Concurrence agency response—with conditions

1 Olsen Avenue - New Auckland, 11 SP112850
(Given under section 285 of the *Sustainable Planning Act 2009*)

Proposed development: Development Permit for a Material Change of Use for a Car Wash

Conceptual Stormwater Management Plan

DRAWING TITLE:
FIGURE 2.2 - POST-DEVELOPMENT CATCHMENT DELINIATION

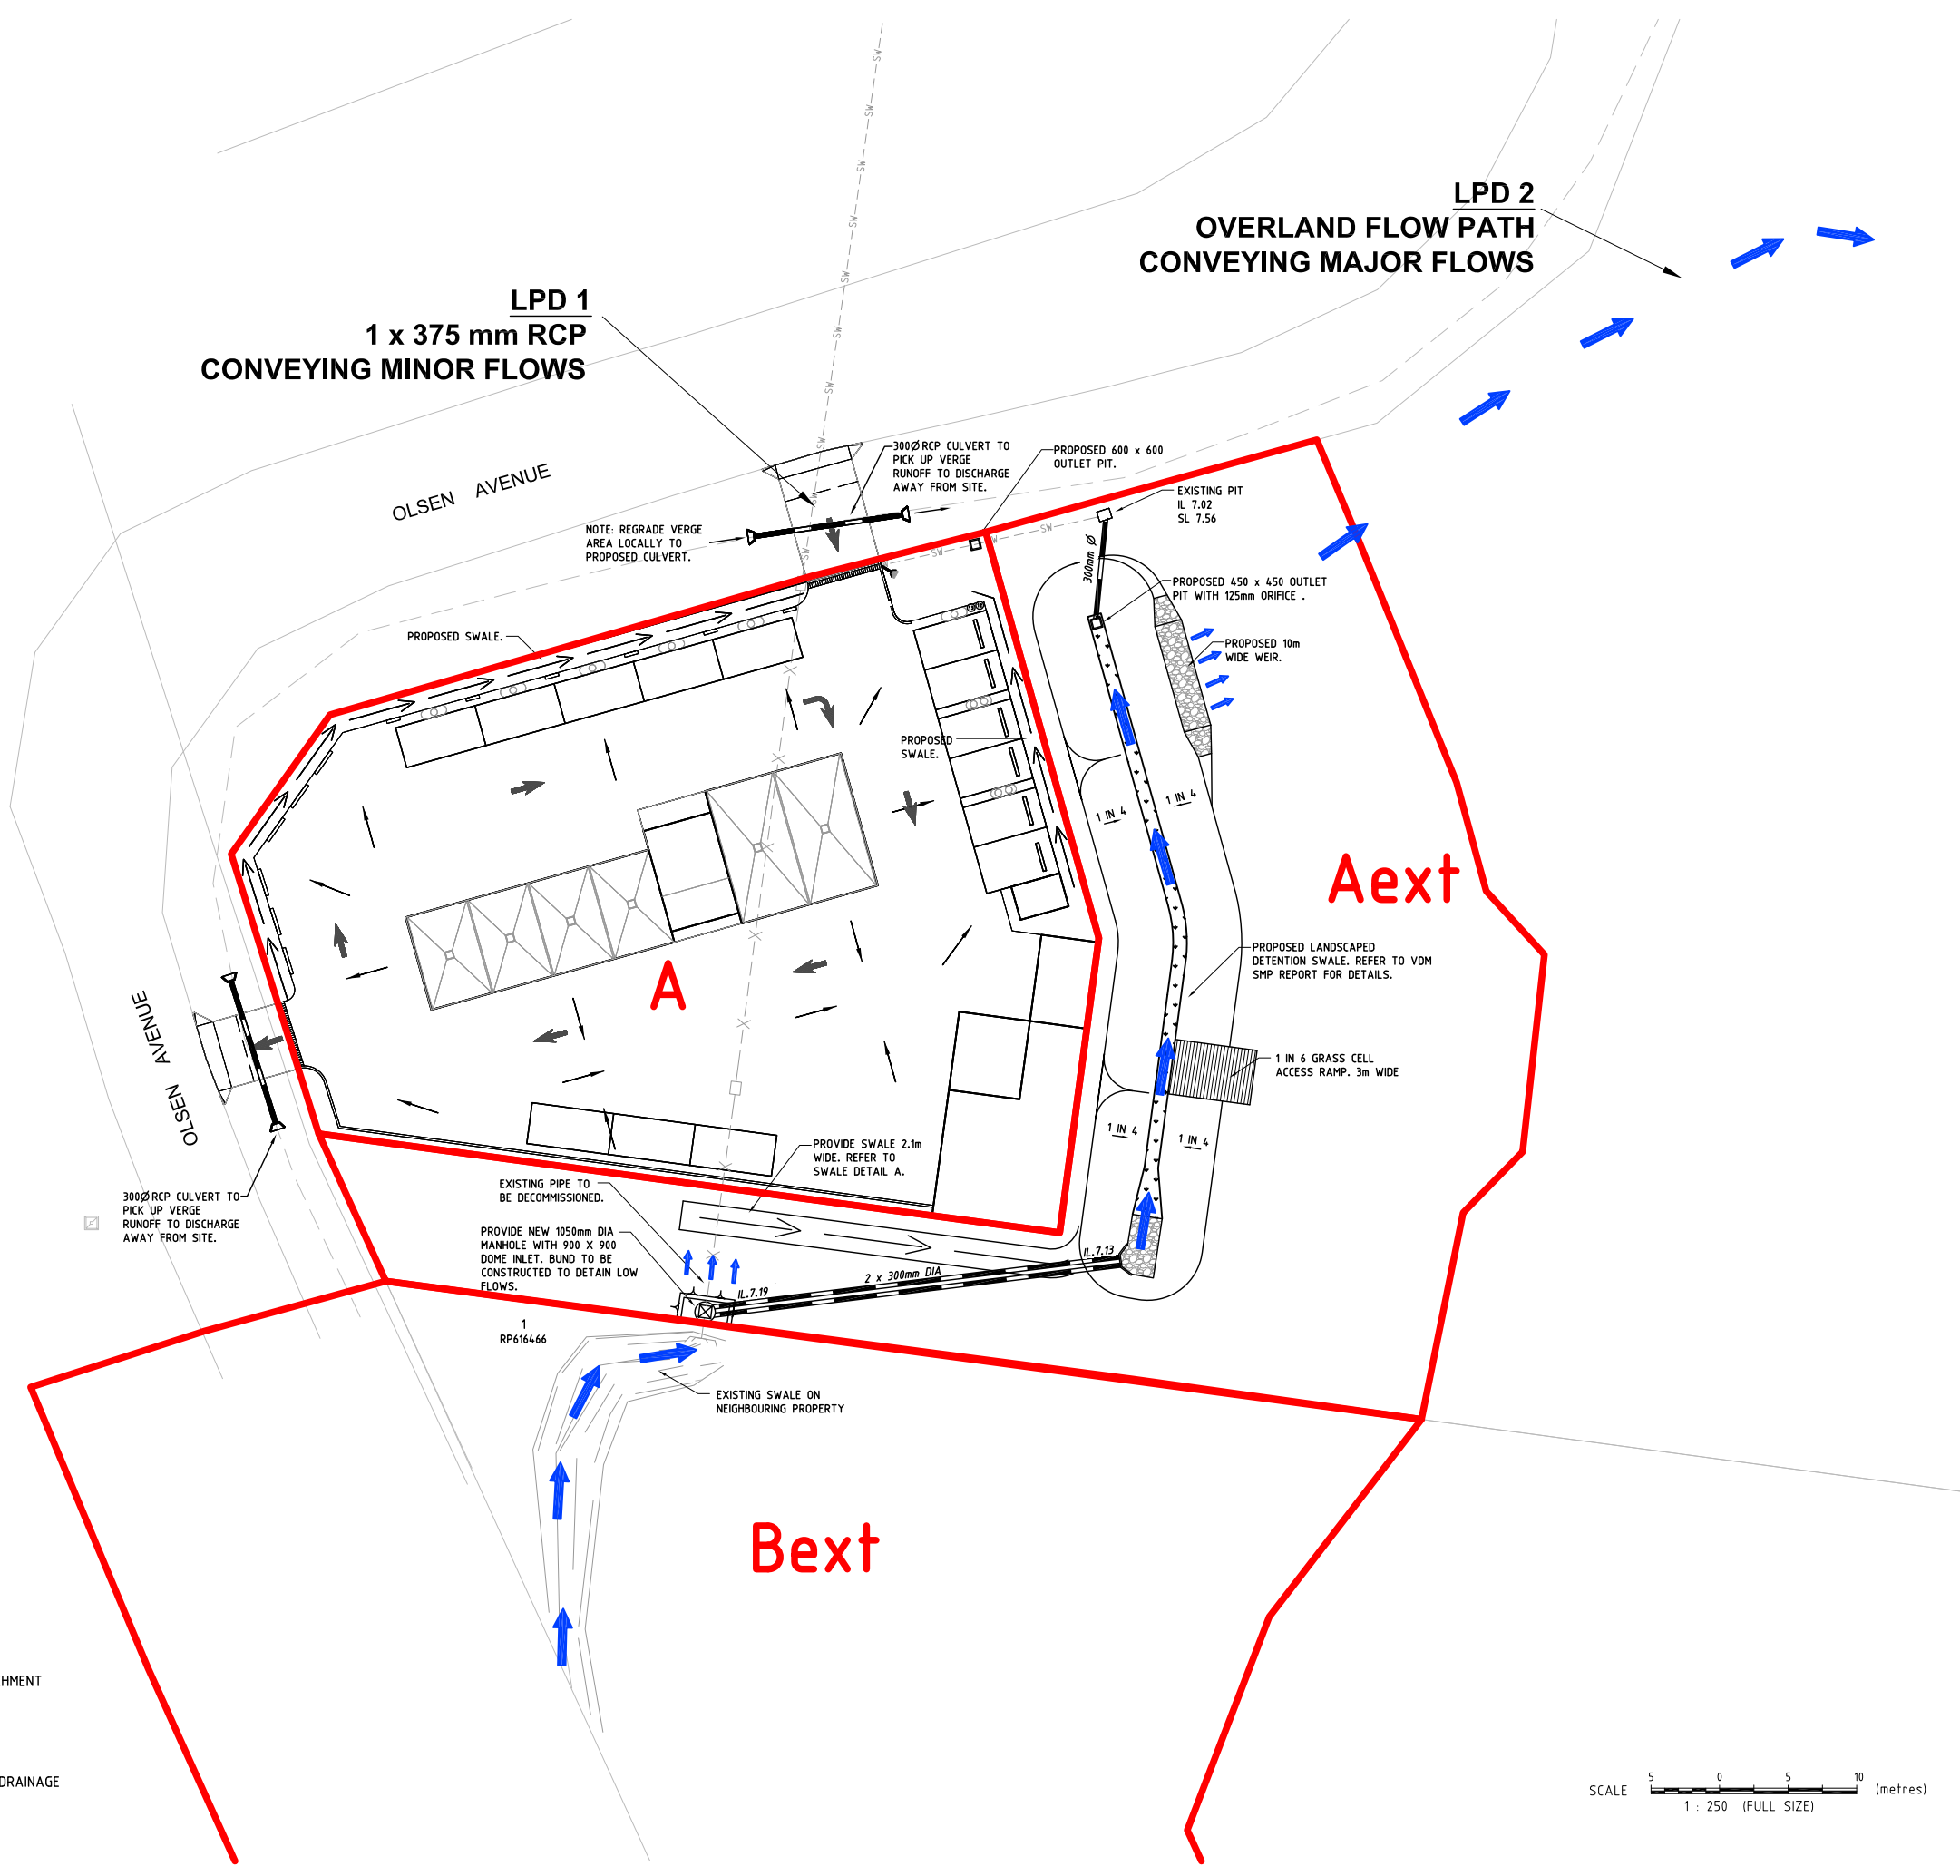
General	
<p>1. The proposed filling of the site has the potential to change the existing overland flow paths across the subject site, particularly draining from the caravan park site. Provide an updated detailed site based Stormwater Management Report for approval that:</p> <p>a) Demonstrates how stormwater runoff between the caravan park and the proposed site will be managed to a lawful point of discharge in a safe and controlled manner;</p>	<p>A 1.33 ha upstream catchment (Ext B) directs minor flows onto the development area via an existing 375 mm pipe and major flows via overland sheet flow. It has been estimated that this upstream catchment will generate a peak discharge of around 0.67 m³/sec during a 100 year ARI.</p> <p>It is estimated that the 375 mm RCP will have a peak capacity of approximately 0.2 m³/sec. Therefore it is estimated that a peak flow of 0.47 m³/sec, will discharge onto the site as sheet flow.</p>

<p>b) Address stormwater issues during a Q₁₀₀ storm event;</p> <p>c) Demonstrate how the proposed driveway accesses into the site will impend stormwater flows on the Olsen Avenue verge.</p> <p>d) Demonstrate to Council that all runoff flows draining towards Olsen Avenue will not create an unacceptable risk to adjoining property owners or road users. This assessment should also consider the consequences of the</p>	<p>It is proposed to decommission the section of the existing 375 mm RCP that is located through the development area. Instead all flows from the upstream catchment will be conveyed via a pipe and open swales to the north eastern corner of the development.</p> <p>As the swale will not grade to an open outlet, a low flow orifice will be provided to drain the swale into the lower portion of the existing 375 mm RCP, which will be retained. As such the swale will act to detain flows from the upstream catchment.</p> <p>Flows in excess of the pipe outlet will be discharged as sheet flow via a grass weir and will flow across the lower portion of Lot 11 on SP112850, as occurs in the pre-development case.</p> <p>All internal flows from the development area will be directed as sheet flow across the hardstand areas and into internal grass swales. These swales will convey flows up to the Q₁₀₀ storm event to the north eastern corner of the site. At this location flows will be collected within a field inlet that will discharge directly into the retained section of the existing 375 mm RCP. Modelling indicates that all flows up to the Q100 from the internal development area will be capable of discharging into the 375 mm RCP which will convey flows under Olsen Ave.</p> <p>Detention has been provided to ensure that peak flow rates will be maintained at the discharge point and the downstream Lawful Point of Discharge (LPD) through the inclusion of on-site detention. This detention system will achieve a Lawful Point of Discharge in accordance with Section 3.02 of QUDM.</p> <p>Culverts have been provided at both driveway access points allow stormwater flows to continue along the Olsen Avenue verge.</p> <p>All internal flows from the development area will be collected within internal grass swale located around the development footprint. These swales will direct flows up to the Q₁₀₀ ARI towards a field inlet pit located in the north eastern corner of the development. Modelling indicates that all flows</p>

<p>Q₁₀₀ storm event in this location.</p>	<p>up to the Q₁₀₀ from the internal development area will be capable of discharging into the 375 mm RCP which will convey flows under Olsen Ave. As such there will be no increase in the existing flows to the Olsen Avenue road reserve.</p>
<p>2. According to VDM's Concept Stormwater Management Plan – Executive Summary (page iii) – it is proposed to offer council a monetary contribution in lieu of providing a bio-retention basin facility on the site. However, VDM's Pre-Development plan SK005 details a proposed bio-retention basin to be constructed on the site. Please advise which option is being applied for.</p>	<p>It is anticipate that a monetary contribution be made lieu of onsite stormwater treatment. All stormwater treatment devices have been removed from the OPW drawings.</p>
<p>3. There is a conflict between VDM's Pre-Development catchment plan Dwg N200 (Ver A) and the Car Wash Builders Site plan Page 1 of 9 (Rev 1). VDM's external catchment plan shows that overland flows will flow in an easterly direction between the Caravan Park and the proposed site, whilst the Site Plan shows these flows drain back into the Caravan Park and onto Olsen Road. Please advise which is correct.</p>	<p>Amended plans have been prepared.</p>

DRAWING TITLE:
STORMWATER DRAINAGE CATCHMENT PLAN

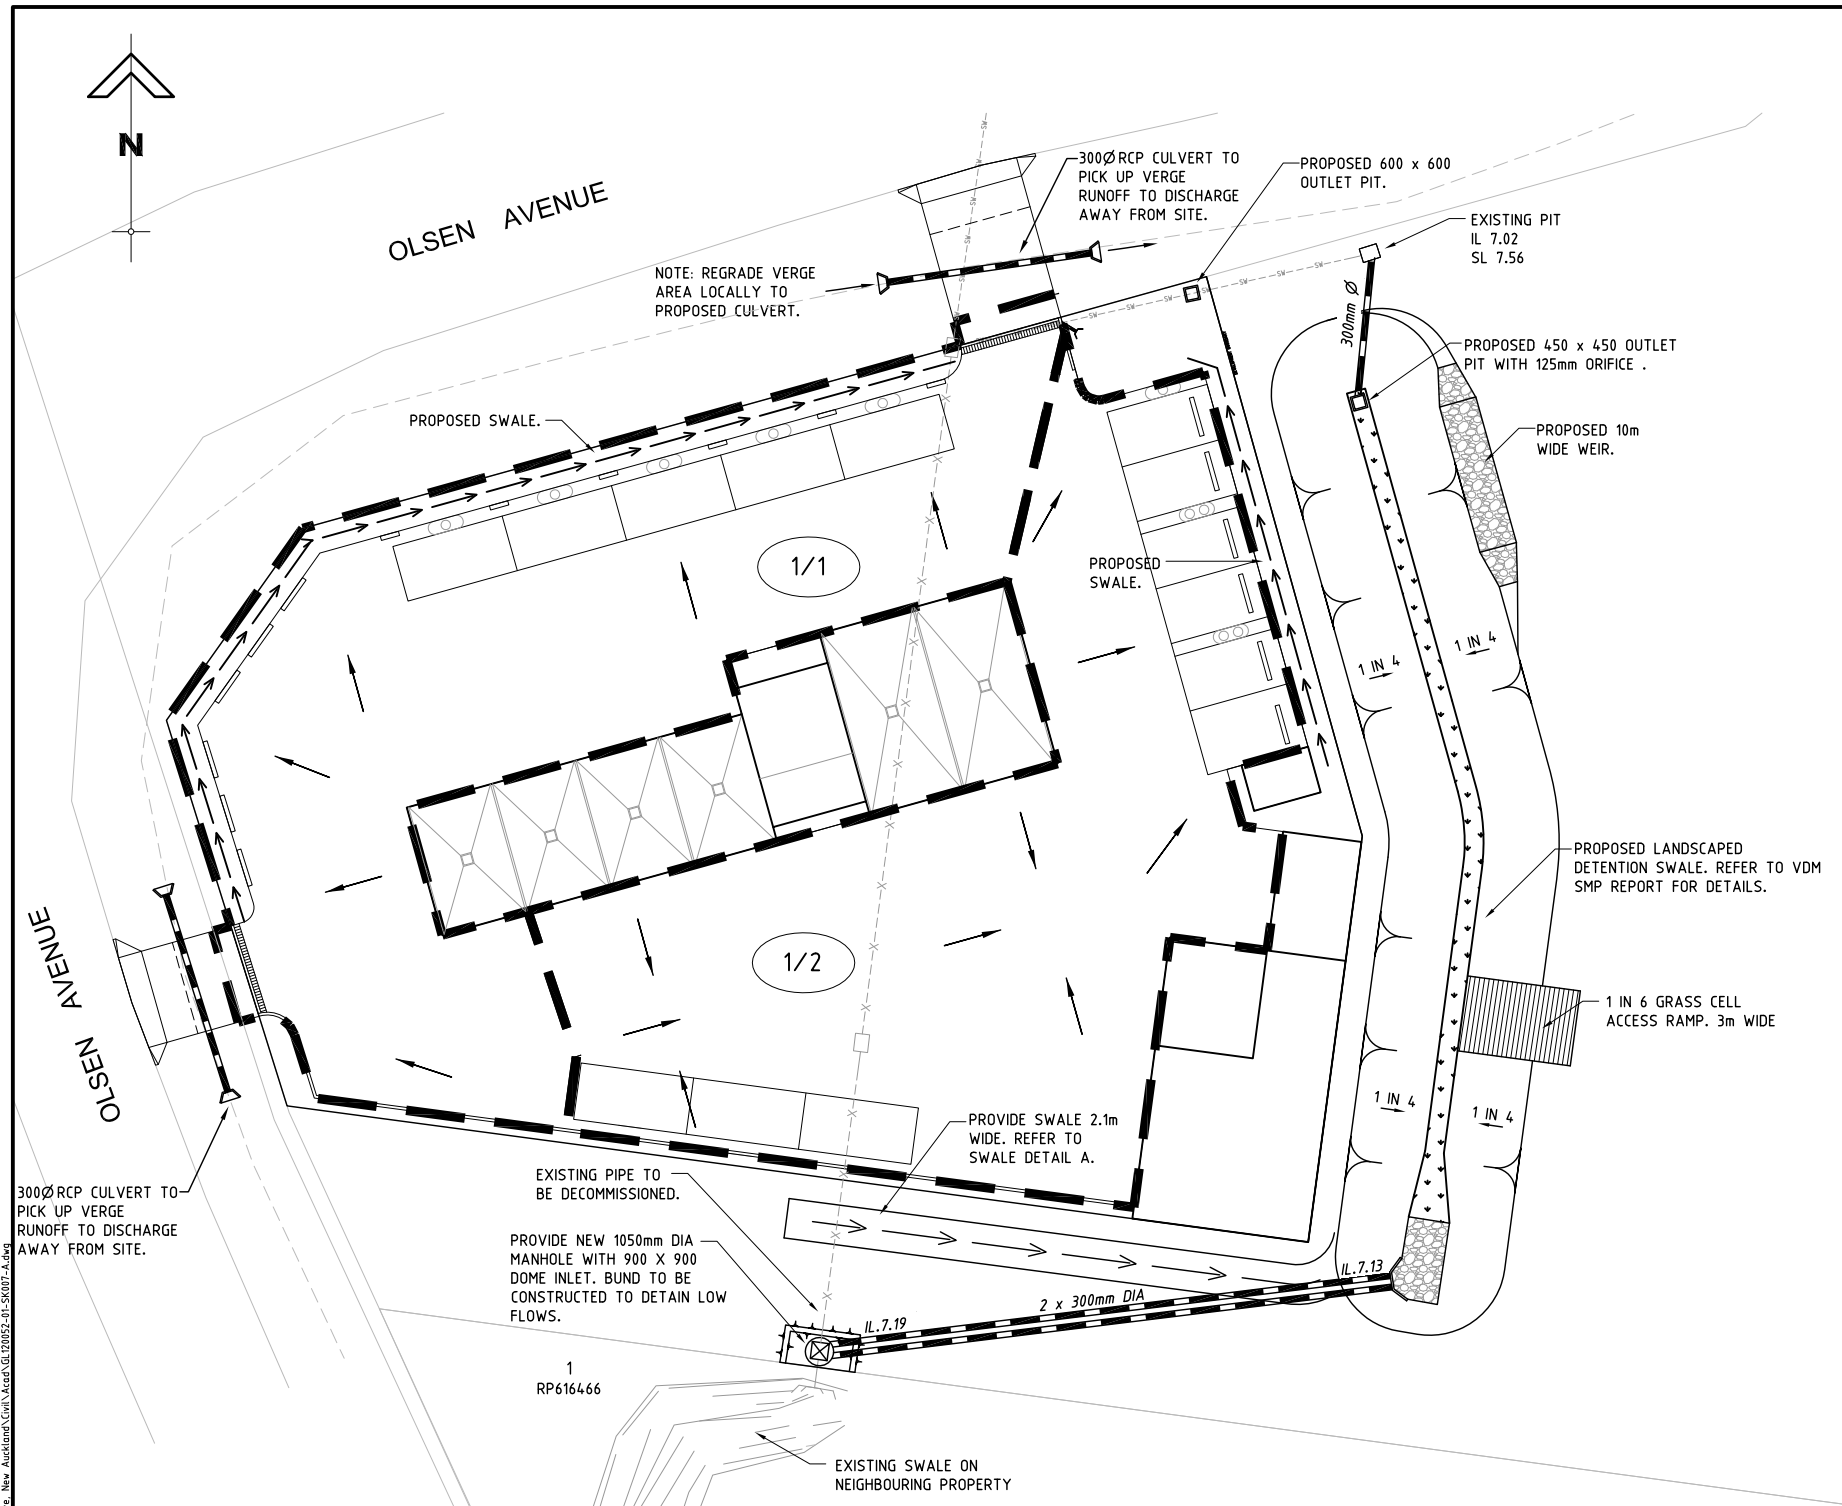
<p>8. Council has identified that the proposed dog wash structure is located within the pathway of concreted stormwater flows from the hardstand area of the development site. Provide amended plans relocating the pathway of the concentrated flows clear of any proposed buildings or relocate the buildings accordingly.</p>	<p>Refer to amended Drawing SK007.</p>
